SUMMARY REPORT
FOR

NAVAL SURFACE WARFARE CENTER, CARDEROCK DIVISION

LVS MOD DEMO VEHICLE
ARMOR PROTECTION KIT INSTALLATION

NATC PROJECT NO. 17859

PHOTOGRAPH NO. 20238-001
LVS ARMOR PROTECTION KIT
FRONT VIEW

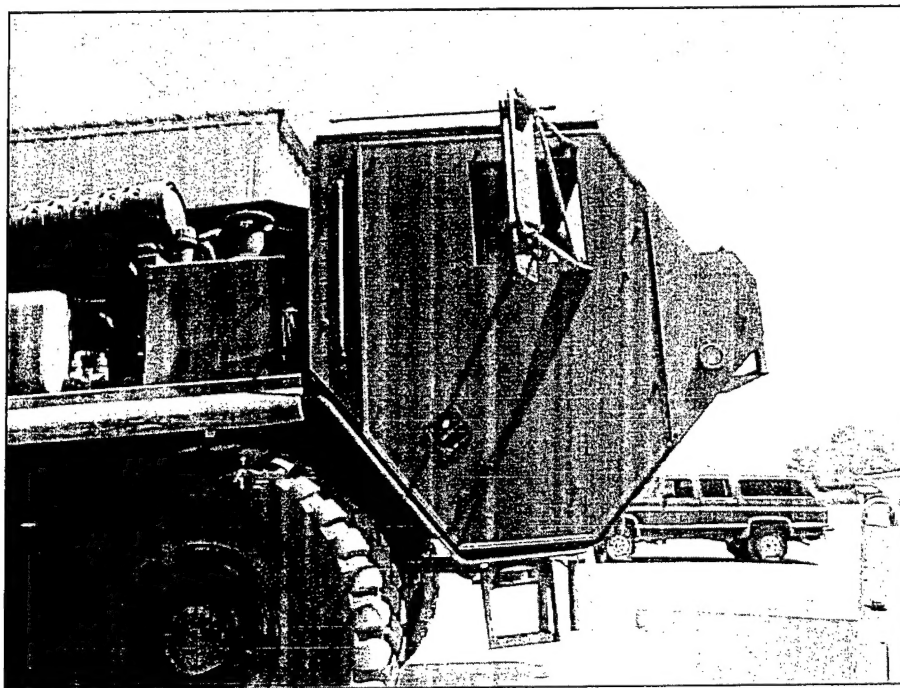
1. The black out lights were not connected through the armor kit (Photograph number 20238-001),
2. The upper clearance lights were not connected through the armor kit (Photograph number 20238-001),
3. Visibility is limited/restricted by the new cab enclosure (Photographs numbered 20238-030 and 031),
4. The air flow is restricted to the cab (Photographs numbered 20238-030 and 031),
5. The window locks may protrude into the occupant's head/body during an accident (Photograph number 20238-016),
6. The door handle (inside cab) is hard to reach next to the seat (Photographs numbered 20238-019 and 020),

7. There is no exit point for the occupants during an accident; i.e., the window can not be kicked out (Photographs numbered 20238-001 through 004),
8. The dead bolt door locks automatically lock during vehicle operation (Photographs numbered 20238-017 and 018),

PHOTOGRAPH NO. 20238-003
LVS ARMOR PROTECTION KIT
DRIVER SIDE VIEW

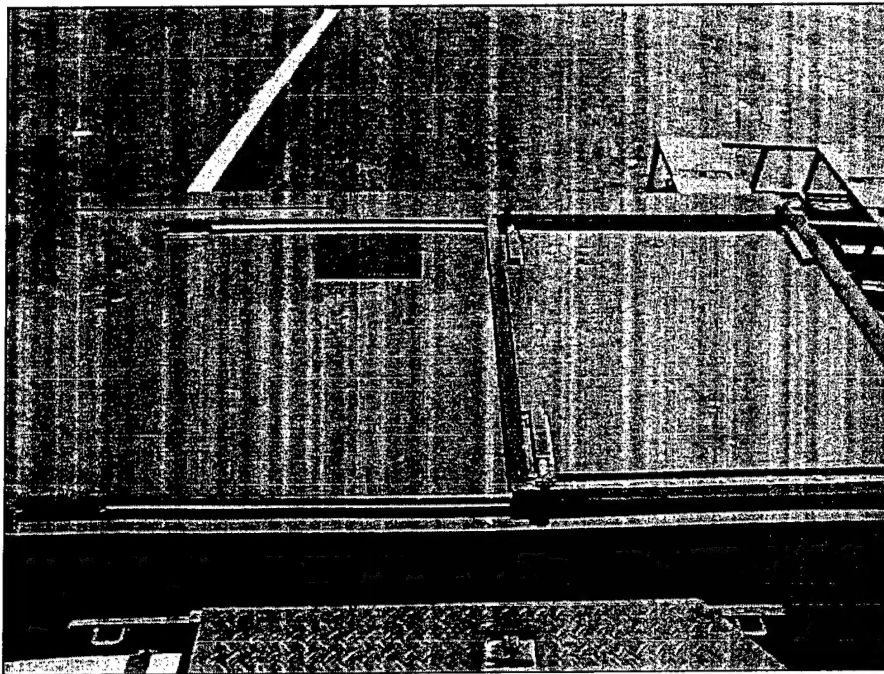
12. The underbody plate will act as a mud trap and corrosion issues are probable (Photographs numbered 20238-003 and 029),
13. The doors are too heavy for the hinges; occupants get trapped inside the vehicle due to hinges getting off track (Photograph number 20238-010),

PHOTOGRAPH NO. 20238-004
LVS ARMOR PROTECTION KIT
TOP CENTER VIEW

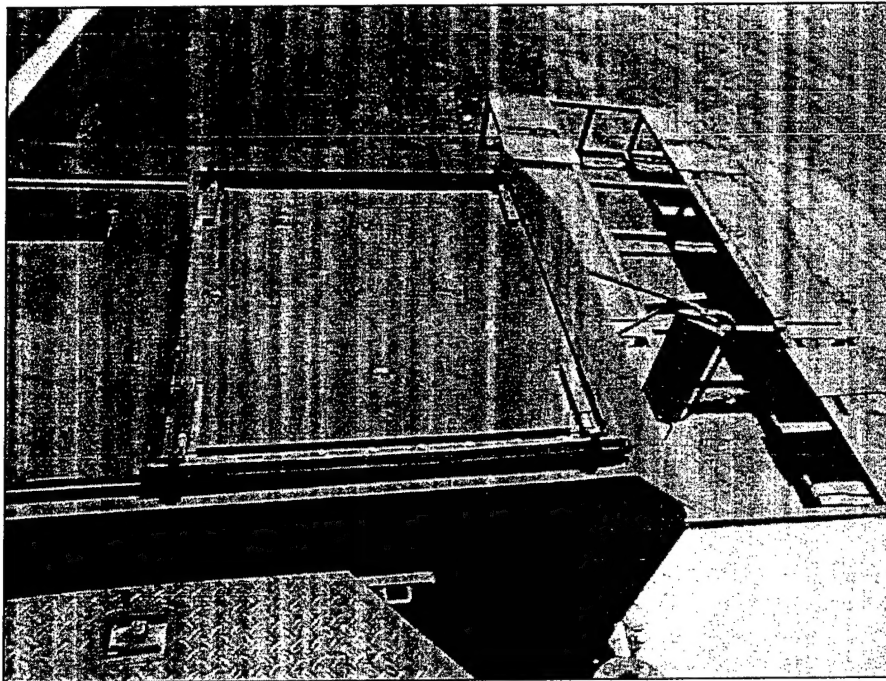
9. The bolts in the roof are protruding into the cab area creating a probability of head injury (Photographs numbered 20238-013 and 015),
10. The roof hatch is hard to lift and does not seem to slide; no 95th percentile provisions (Photographs numbered 20238-004 and 005),

PHOTOGRAPH NO. 20238-011
LVS ARMOR PROTECTION KIT
UPPER DOOR PIN LOOSE – CONTACT MARKS FROM DOOR

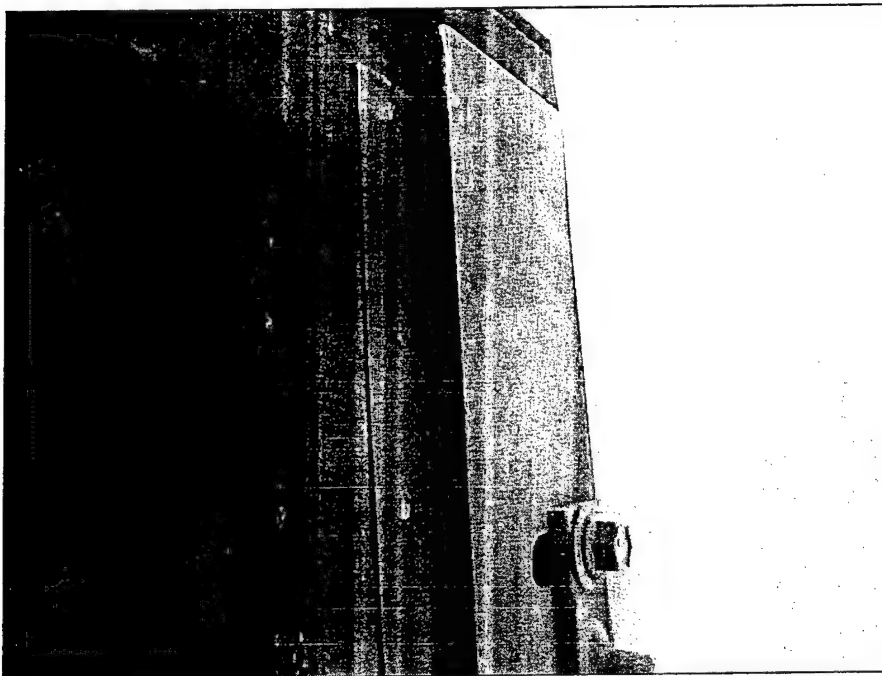
16. The driver and passenger side upper door pins are loose (Photograph number 20238-011),
17. There is a gap in the armor plate on both sides; only one bolt holds the armor kit on, the other bolt is only through the sheet metal (Photograph number 20238-012),

PHOTOGRAPH NO. 20238-013
LVS ARMOR PROTECTION KIT
PROTRUDING BOLTS – DRIVER'S SIDE ROOF

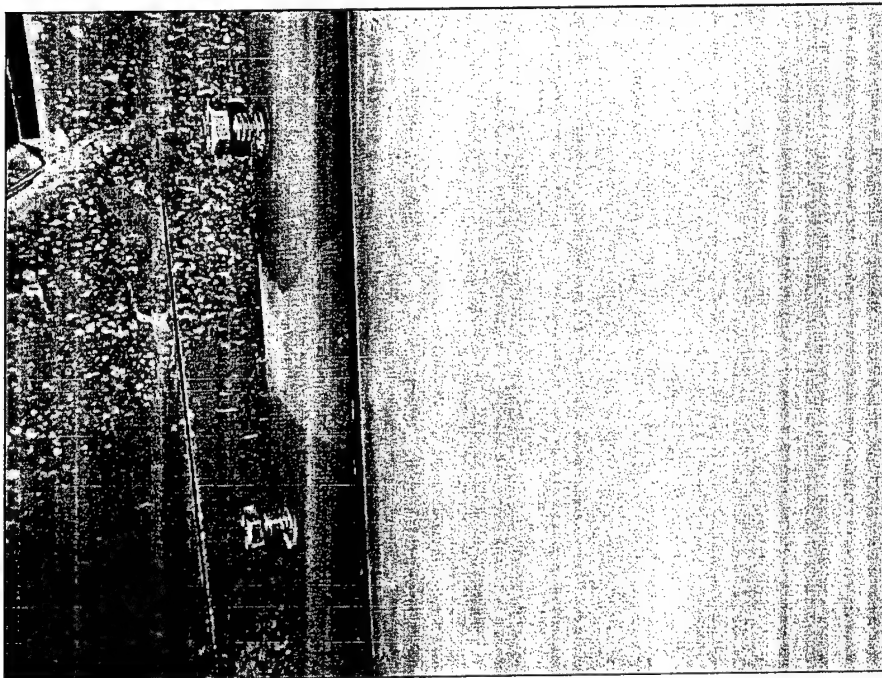
11. The entire cab has protruding bolts into the cab space creating a probability of head injuries (Photographs numbered 20238-013, 014, 015, 023, 024, 025 and 027),

PHOTOGRAPH NO. 20238-021
LVS ARMOR PROTECTION KIT
DRIVER SIDE CAB MOUNTS

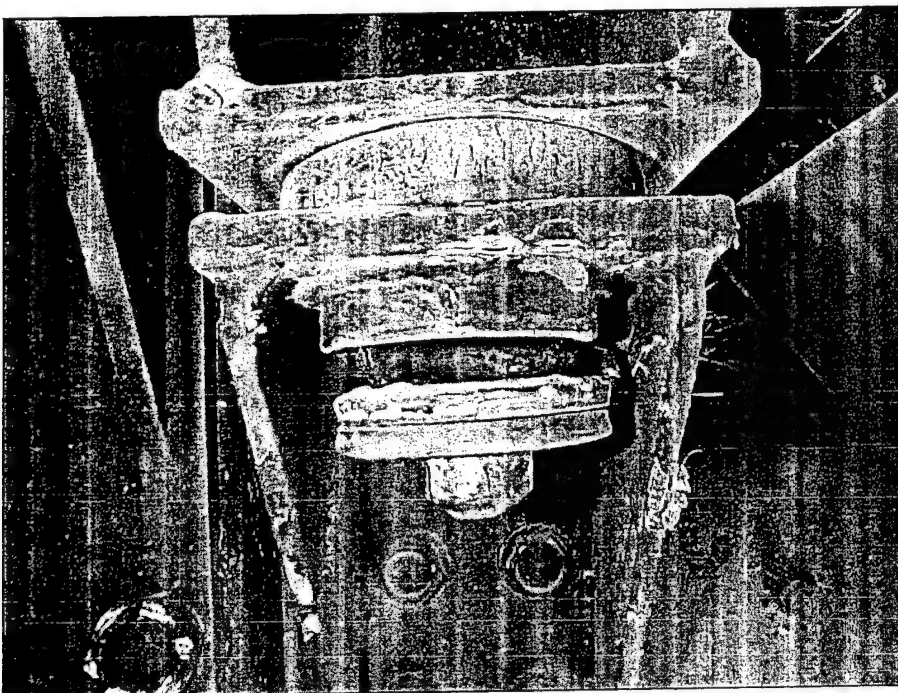
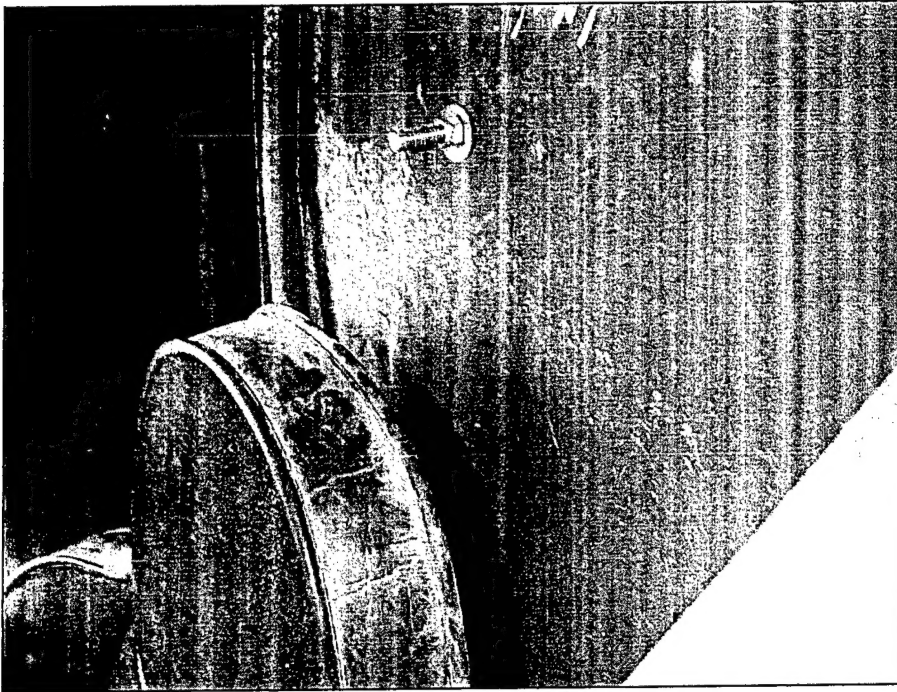
19. There is no access to clean the headlights; space will serve as a mud trap (Photograph number 20238-028), and
20. The cab mounts are deteriorating due to the additional weight (Photographs numbered 20238-021 and 022).

1. Address the twenty-one items identified should further development be merited.
2. Perform accelerated fatigue testing of the vehicle.
3. Redesign the cab mounts to consist of a stiffer material.

PHOTOGRAPH NO. 20238-024
LVS ARMOR PROTECTION KIT
PROTRUDING BOLTS PASSENGER SIDE

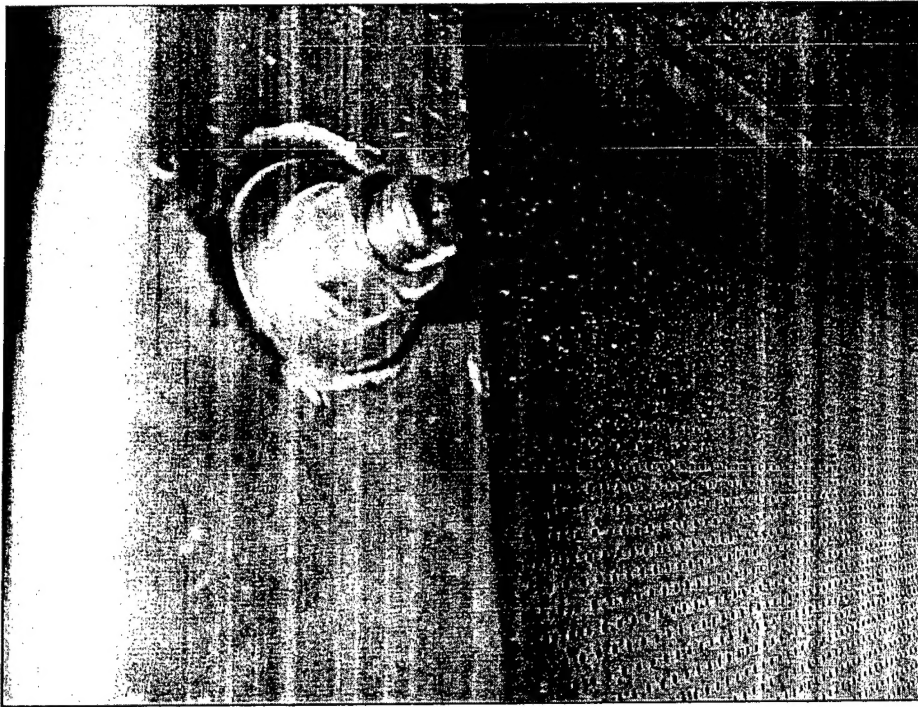
14. The armor kit is bolted through the gunner's platform; platform not operational (Photographs numbered 20238-024 and 027),
15. The cab structure tube is crushed due to no support for bolts (Photograph number 20238-025),

PHOTOGRAPH NO. 20238-026
LVS ARMOR PROTECTION KIT
NYLON BOLT NOT ENGAGED

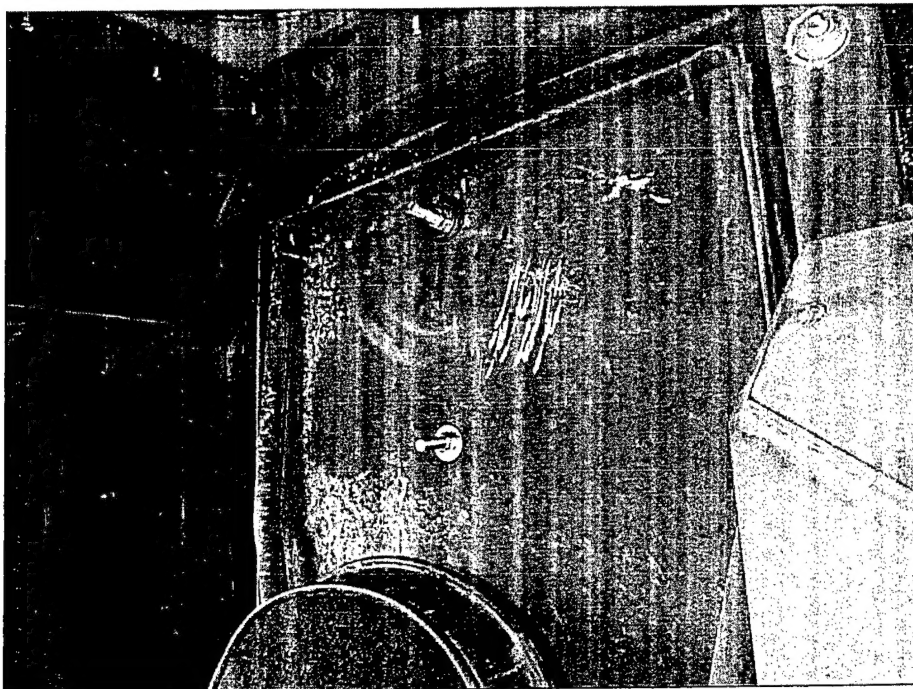
18. There is no thread engagement on the nylon bolts inside the cab in the front and gunner's hatch areas (Photograph number 20238-026),
